Intel[®] 865G/865GV/865PE/865P Chipset

Platform Design Guide Update

August 2004

Document Number: 301120-004

2. Replace Figure 46 "Routing Illustration for BOOTSELECT"

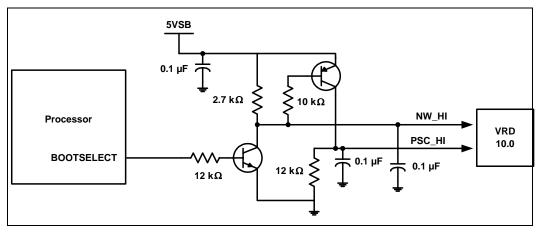
In Section 5.1.6.10 on page 80, replace Figure 46 "Routing Illustration for BOOTSELECT" with the following:
